United States Steel Corporation

DUCKET NUMBER
PROPOSED RULE

Comments on 10 CFR 40.32
General Requirements for Issuance of
Specific Licenses

Comments on the Generic Environmental
Impact Statement on Uranium Milling

FLOW DIAGRAM FOR A CONVENTIONAL URANIUM OPEN PIT/ACID - LEACH MINING PROCESS.

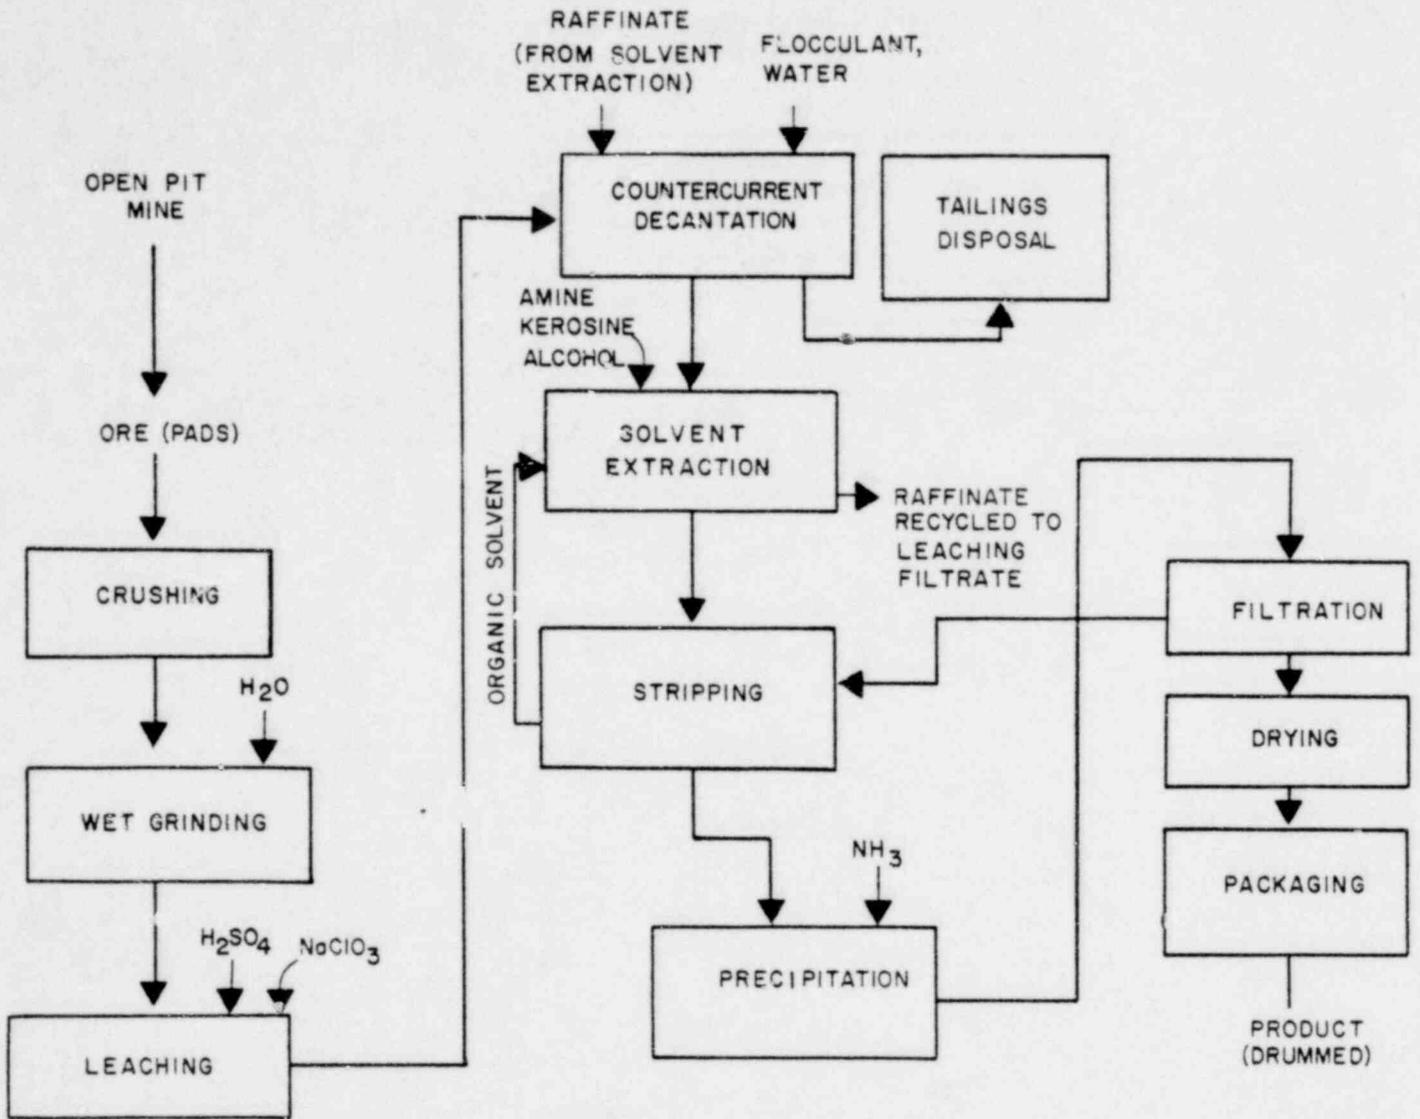
Justification - The surface recovery of uranium in the in-situ process is not by conventional milling unit operations. There is no ore pad, no ore crushing or grinding, and no tailings pile; the leaching process is usually alkaline instead of acidic, and the extraction process is almost exclusively ion-exchange instead of solvent. The typical in-situ recovery plant is radically different from conventional milling unit operations (see attachments 1 and 2).

Suggested change - Delete the last phrase, "by conventional milling unit operations."
